Item ID: D206-667-103

Item Name: Crosstube Fwd

DRAWING NO. D206-667-143	TITLE CROSSTUBE ASS'Y (206L HIGH FWD)	REV. C	<b>DART AEROSPACE LTD ENGINEERING ORDER</b>		D.E.O. NO. D206-667-143-C-1	SHEET NO. SHEET 1 OF 1	SCALE NTS
DRAWN <i>97</i>	CHECKED <i>ASS</i>	MFG. APPR. <i>[Signature]</i>	APPROVED <i>[Signature]</i>	DE APPR. <i>[Signature]</i>			
DATE 11.07.15	DATE 11.07.20	DATE 11.07.21	DATE 11/07/21	DATE 11.07.21

DRAWING NO. D206-667-143	TITLE CROSSTUBE ASS'Y (206L HIGH FWD)	REV. C	DART AEROSPACE LTD ENGINEERING ORDER		D.E.O. NO. D206-667-143-C-2	SHEET NO. SHEET 1 OF 1	SCALE NTS
DRAWN AJS	CHECKED	MFG. APPR. <i>E</i>	APPROVED <i>AP</i>	DE APPR. <i>MS</i>			
DATE 12.08.02	DATE 12.08.02	DATE 12.08.02	DATE 12.08.02	DATE 12.08.02	DATE 12-08-02

DESIGN	90	<b>DART AEROSPACE LTD</b>
DRAWN	RF	HAWKESBURY, ONTARIO, CANADA
CHECKED	EF	DRAWING NO. D206-667-143
MFG. APPR.	EF	REV. C SHEET 3 OF 4
APPROVED	EF	TITLE SCALE
DE APPR.	EF	CROSSTUBE ASSY (206L HIGH FWD) NTS
DATE	08.11.06	COPYRIGHT © 2000 BY DART AEROSPACE LTD

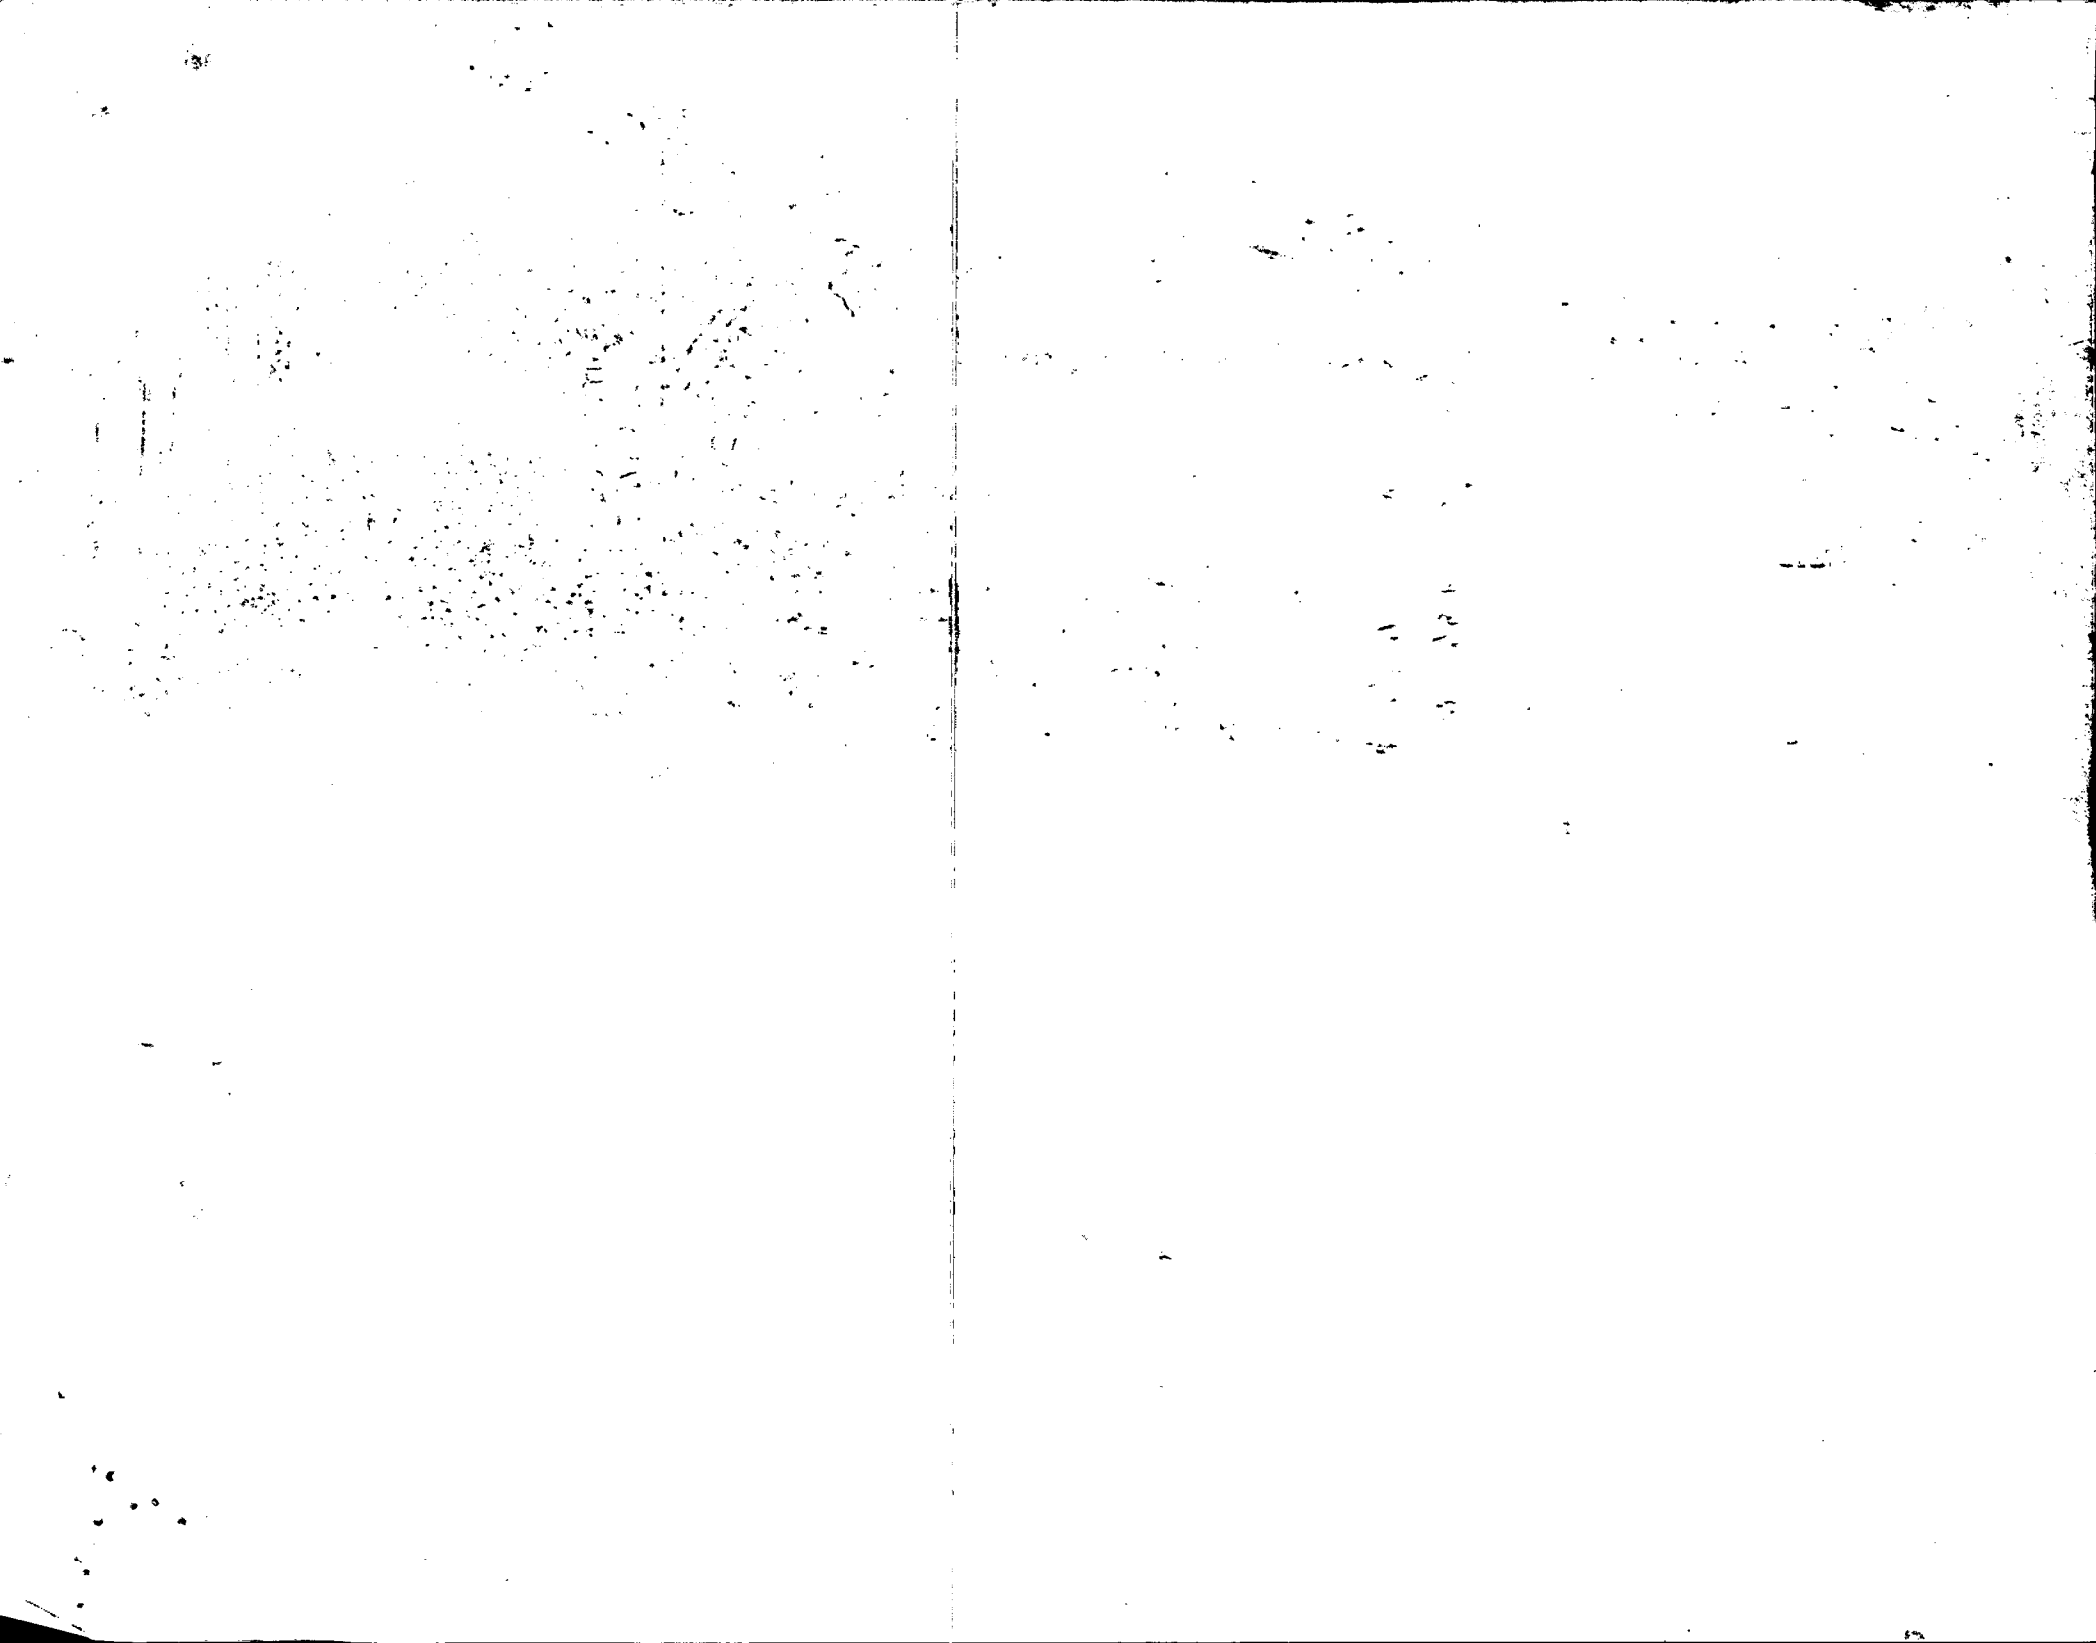
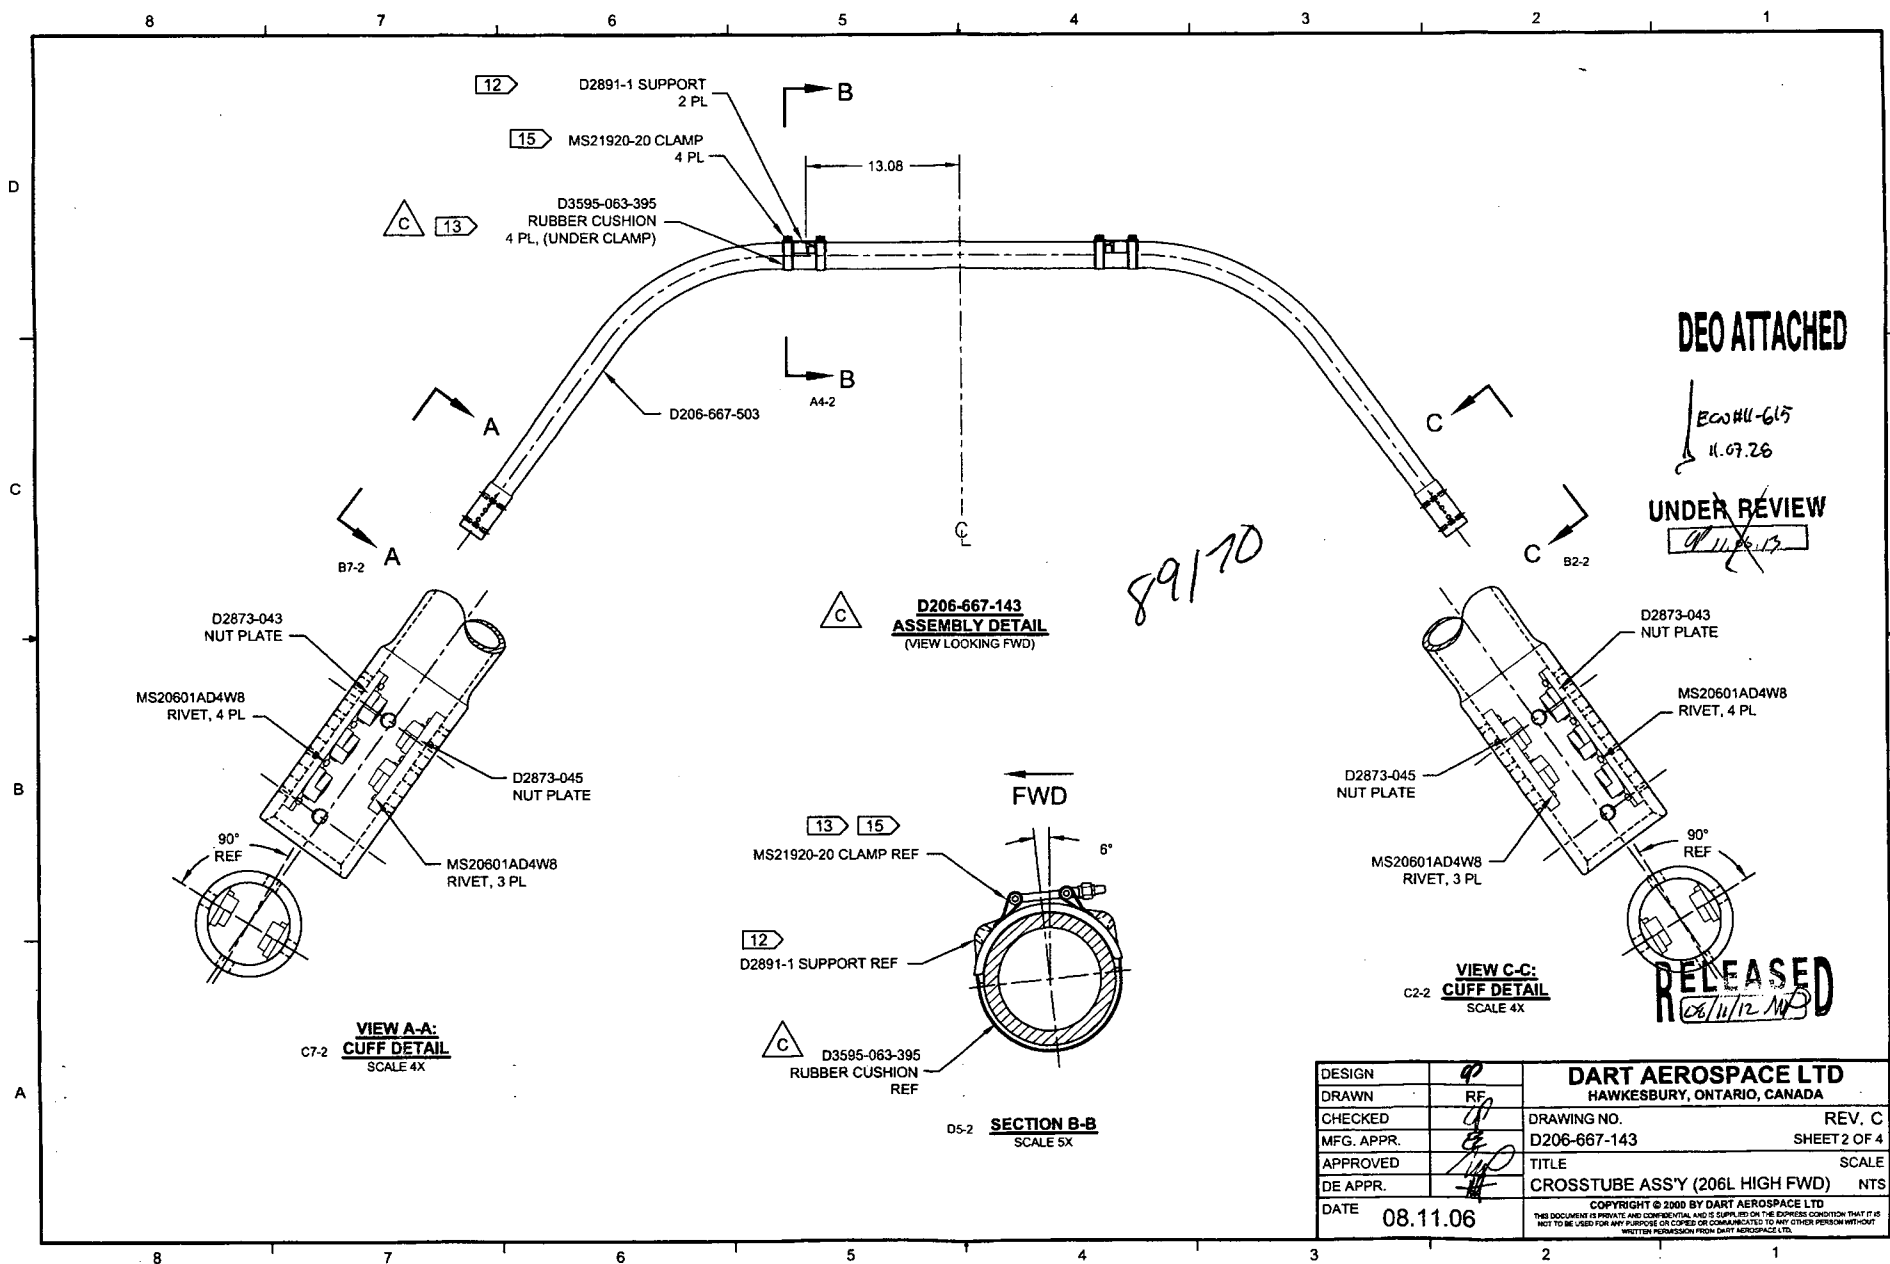
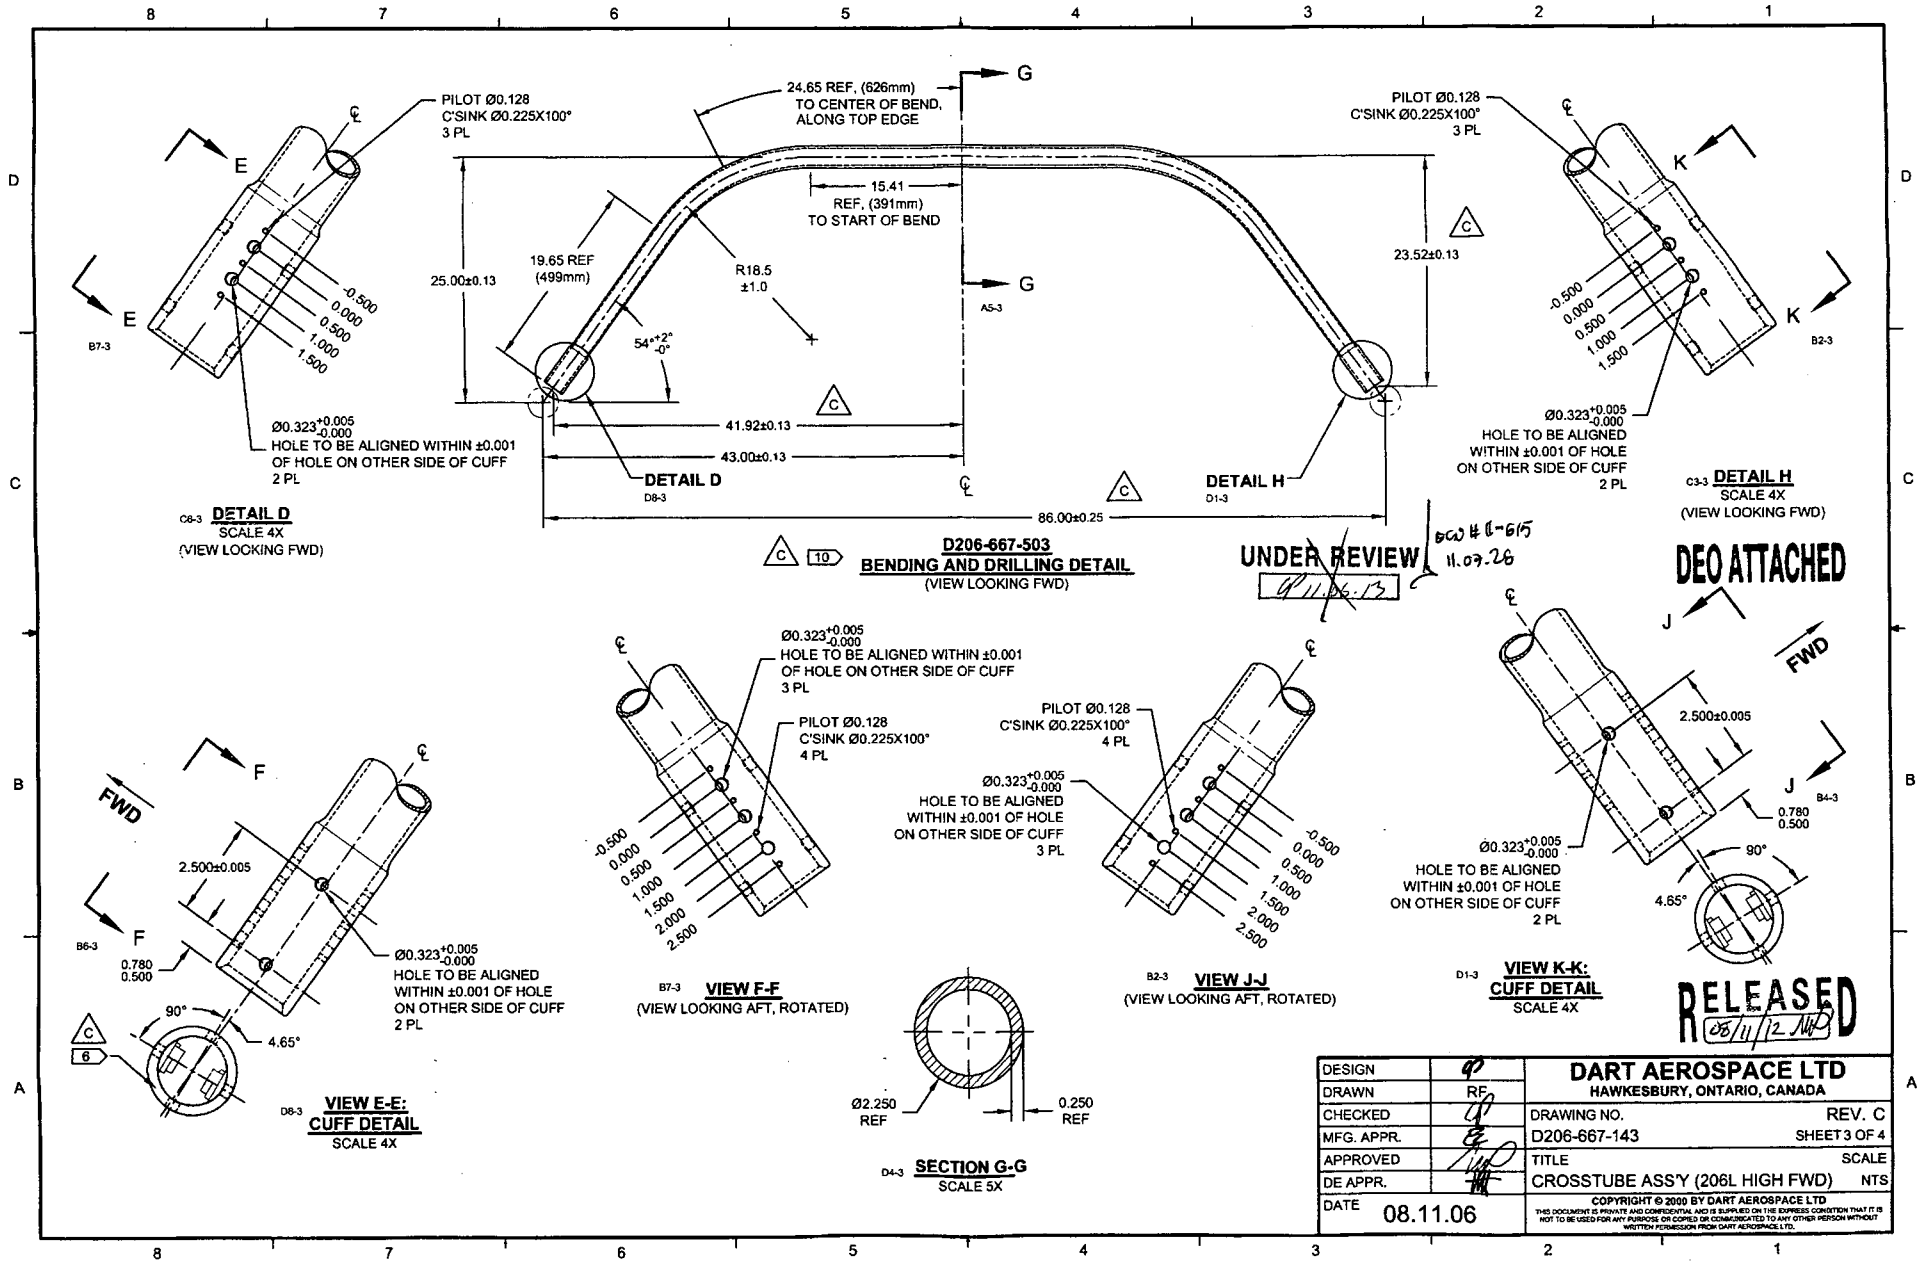
REPLACE MAGNOBOND WITH PROSEAL.

NOTE 12 & 15, SHEET 1 IS AMENDED AS FOLLOWS:

- 12) TO INSTALL D2891-1 SUPPORT: ABRASE MATING SURFACE OF SUPPORT AND CROSSTUBE WITH 180-GRIT SANDPAPER AND REMOVE RESIDUE WITH MEK (OR EQUIVALENT). APPLY A 0.04" TO 0.07" THICK LAYER OF PROSEAL 890 CLASS B-2 (OR AMS-S-8802 CLASS B-2) SEALANT TO MATING SURFACE OF SUPPORT.
- 15) TORQUE CLAMPS 80 TO 100 IN-LB. ENSURE AT LEAST 1.5 THREADS SHOWING IN SAFETY AND THAT NUT HAS NOT BOTTOMED-OUT AFTER TORQUING. **PRIOR TO PACKAGING, RE-CHECK TORQUE ON CLAMPS AFTER PROSEAL 890 SEALANT HAS CURED FOR 72 HOURS.**

**DETAIL P**  
BONDING STRAP INSTALLATION 2 PL

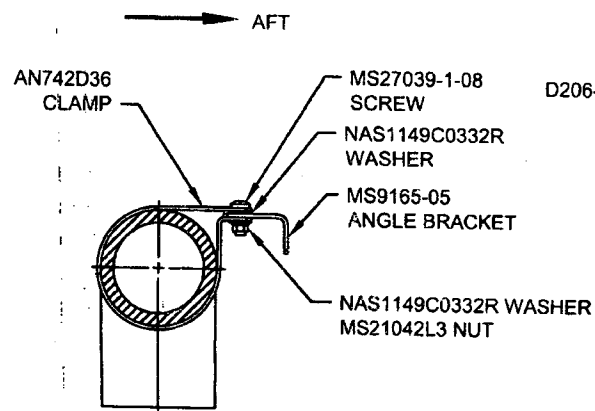
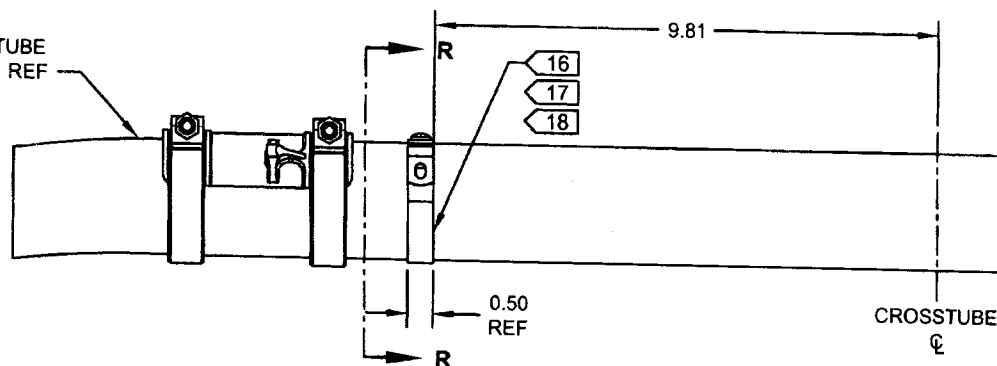
ADD ELECTRICAL GROUNDING STRAP

ADD

10	2	AN742D36	CLAMP
11	2	MS9165-05	ANGLE BRACKET
12	2	MS21042L3	NUT (OR MS21042-3)
13	2	MS27039-1-08	SCREW
14	4	NAS1149C0332R	WASHER (OR AN960C10L)
